**Objection to Planning Application 2024/5407/P & 2024/5423/L
Gardeners' Building, Highgate Cemetery (East Mound)**

Objections on Submitted Proposals for a Gardeners Building

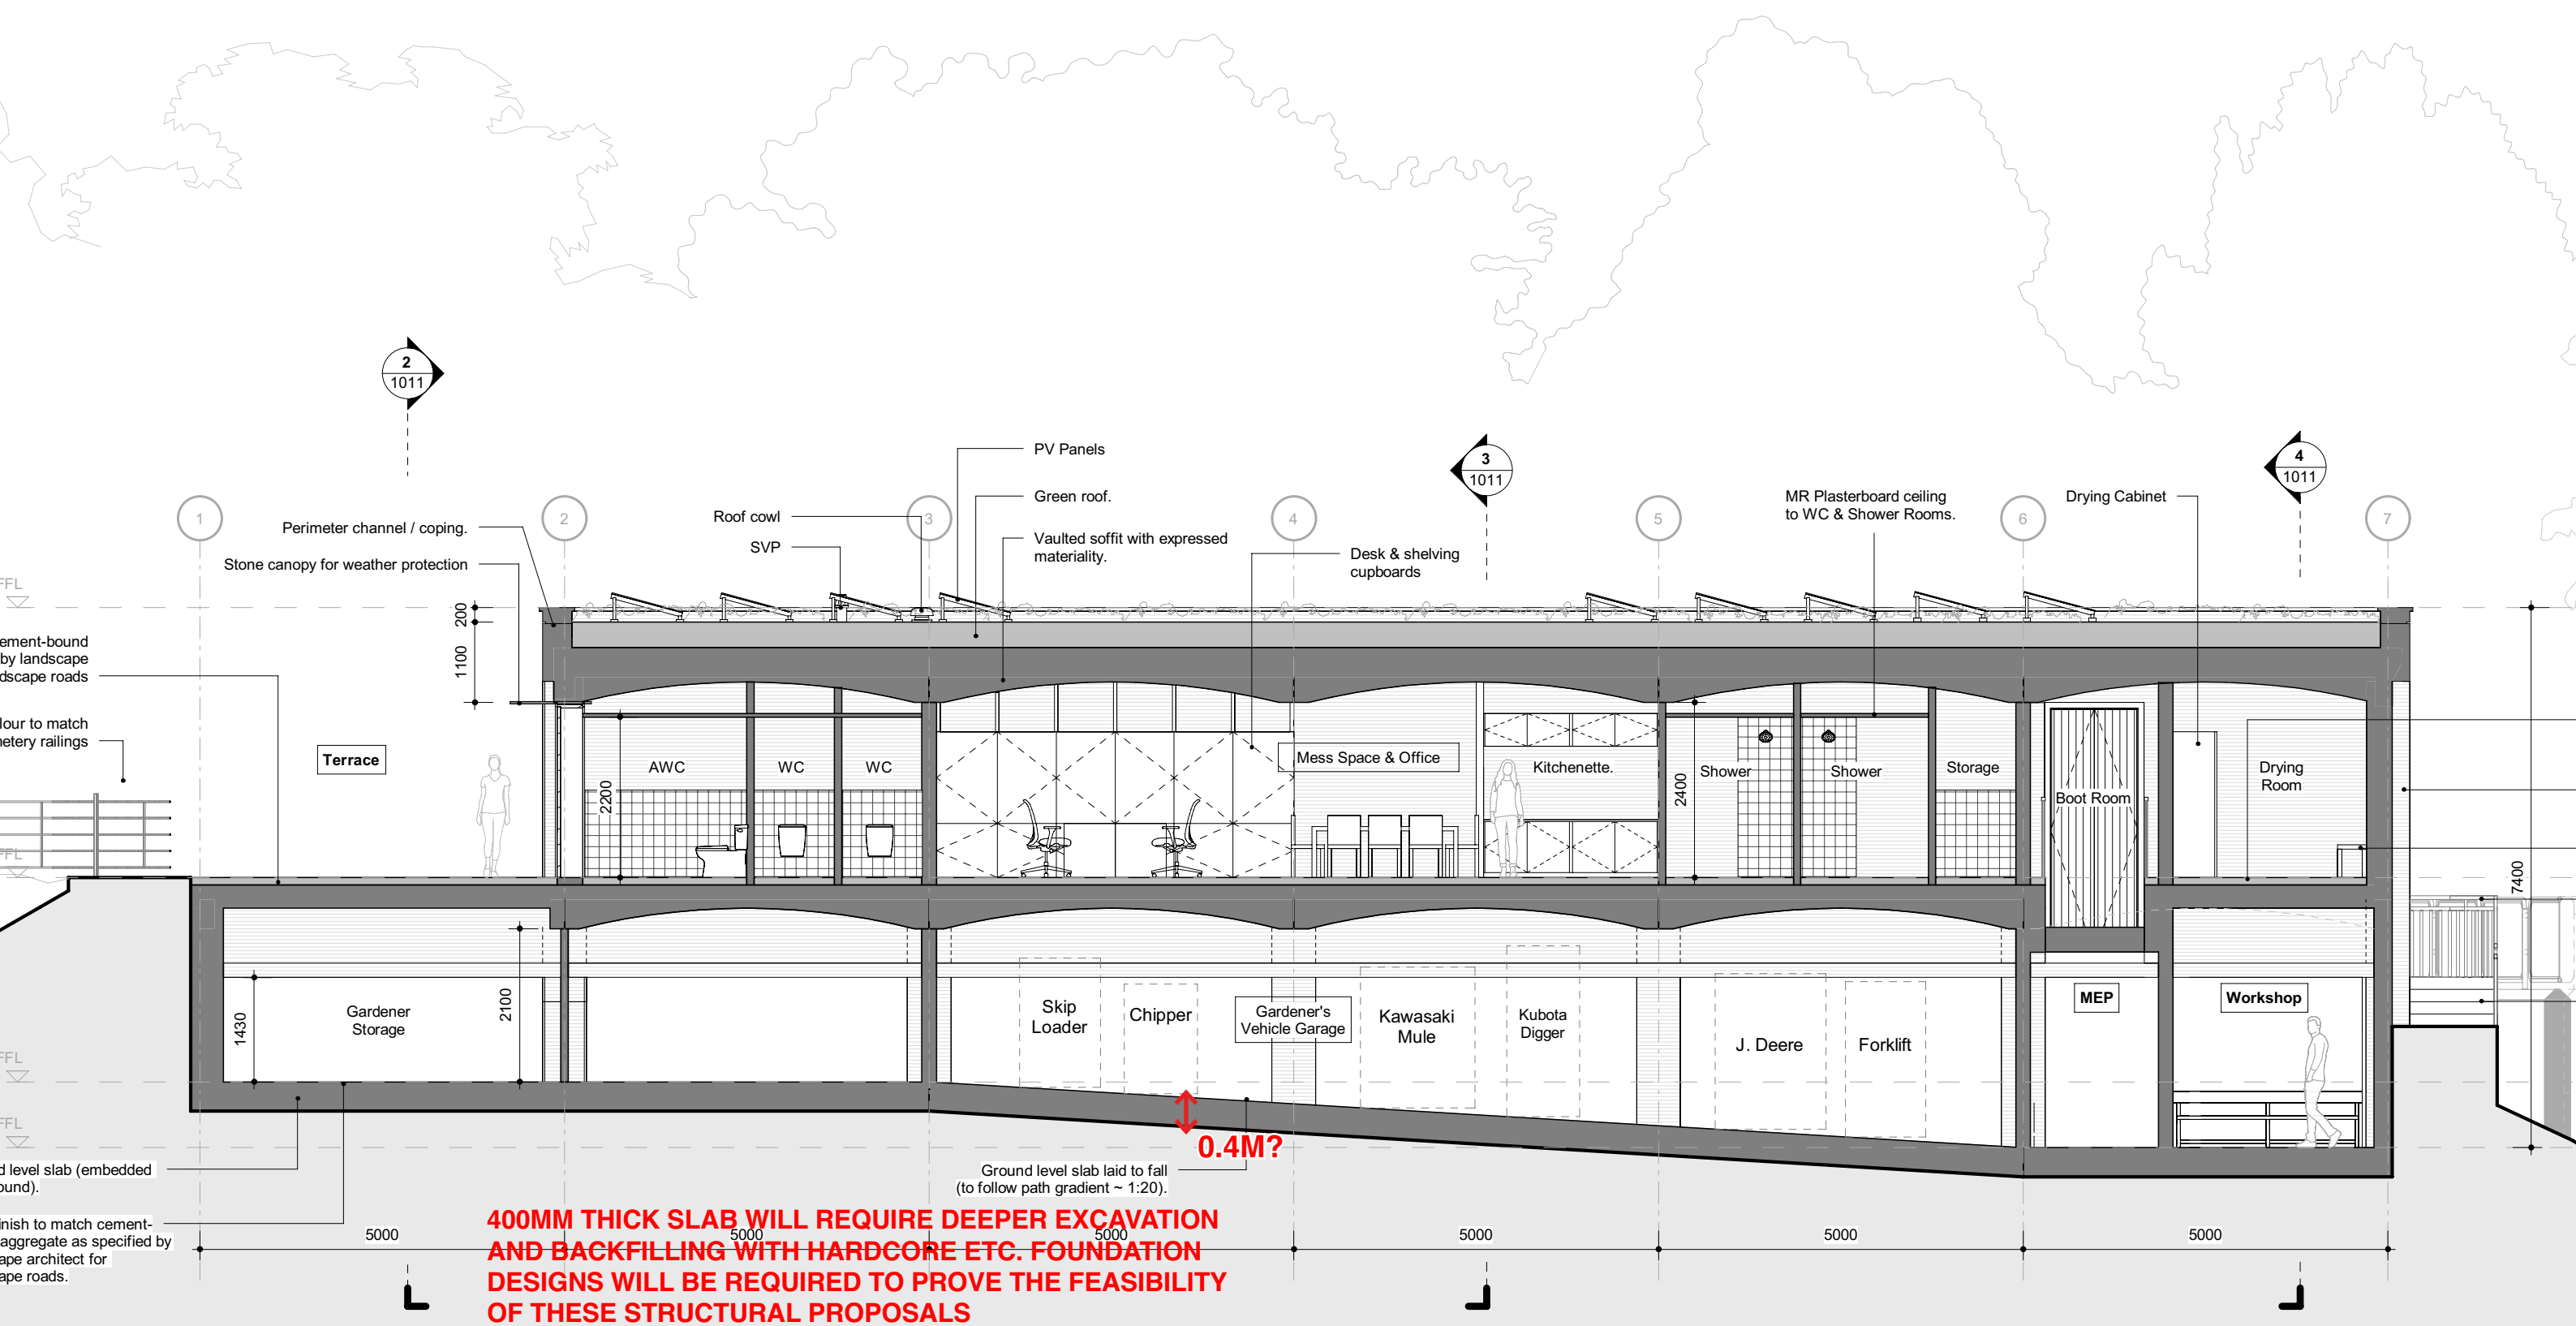
WITHOUT FOUNDATION DESIGNS, IT'S NOT POSSIBLE TO ACCEPT THE VALIDITY OF WHAT IS DEPICTED ON THIS DRAWING. THE DRAWING SHOWS A TWO STOREY BUILDING OF HEAVY CONSTRUCTION FLOATING ON A RAFT. AS THE GROUND BENEATH ARE ANCIENT GRAVES, IT IS HIGHLY LIKELY THAT THE GROUND CONDITIONS WILL NECESSITATE PILES OR DEEP STRIP FOUNDATIONS OR A MUCH THICKER SLAB. ALL OF THESE OPTIONS WILL MORE THAN LIKELY IMPACT ON THE GRAVES BENEATH.

2 East Elevation - Gardeners' Building
1012

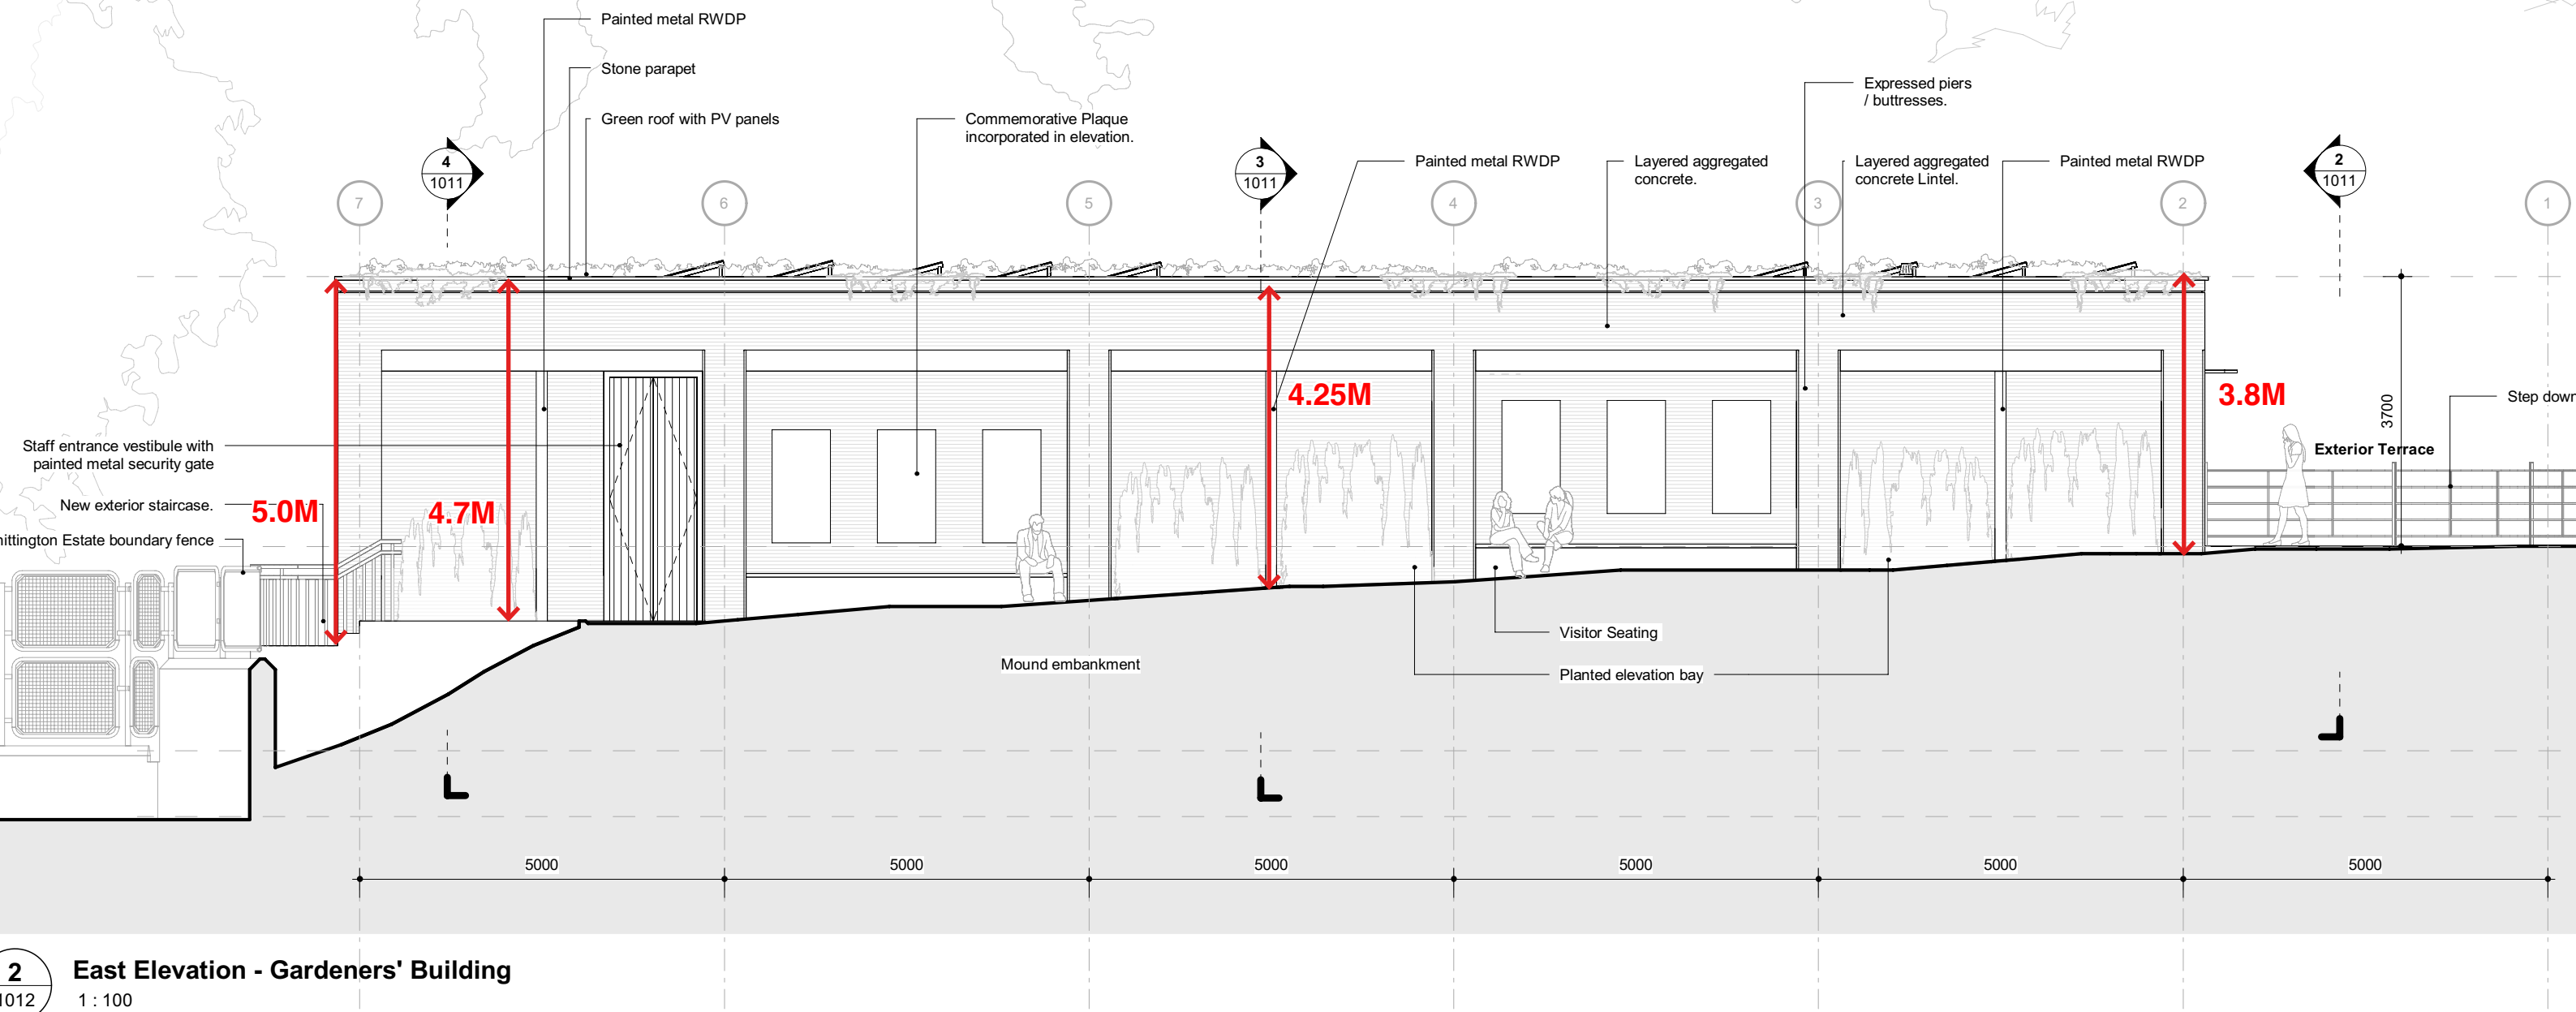
A 4M HIGH FUNERIAL/CREMATORIAL TYPE BUILDING BUILT HARD UP AGAINST A 1.05M WIDE PATH ON THE MOUND IS INCONGRUOUS WITH THE SETTING OF THE LISTED LANDSCAPE WITH REGARDS TO OPENNESS AND IT' PHYSICAL SHEER IMPACT ON THE HISTORIC SETTING

Gardeners' Building- East Elevation

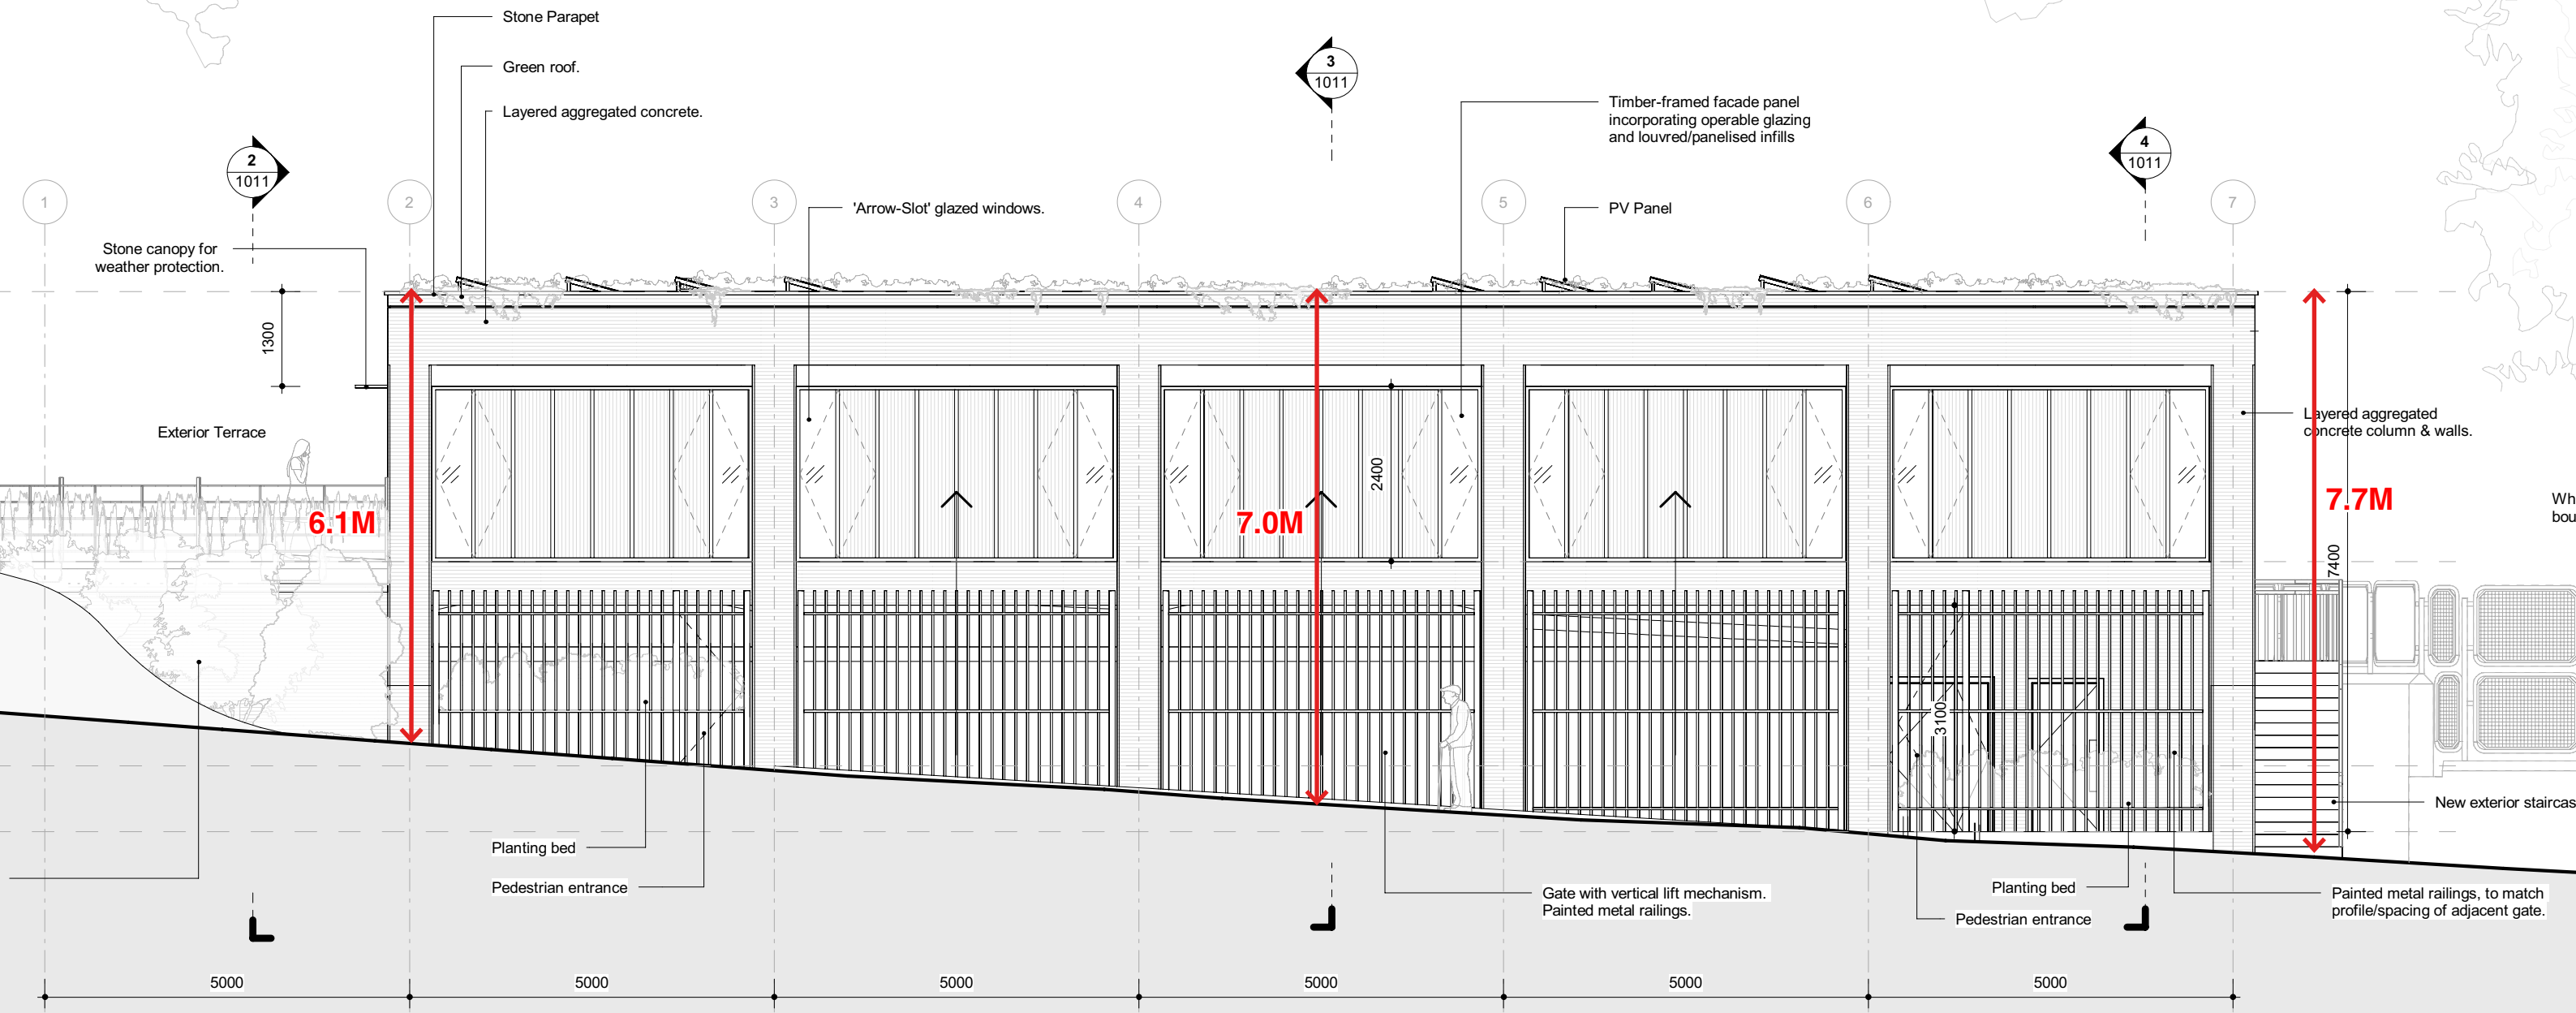
A 7.7M HIGH BUILDING BUILT HARD UP AGAINST A 2.5M WIDE PATH THROUGH THE CEMETERY IS INCONGRUOUS WITH THE SETTING OF THE LISTED LANDSCAPE AND IT'S PHYSICAL SHEER IMPACT ON THE HISTORIC SETTING
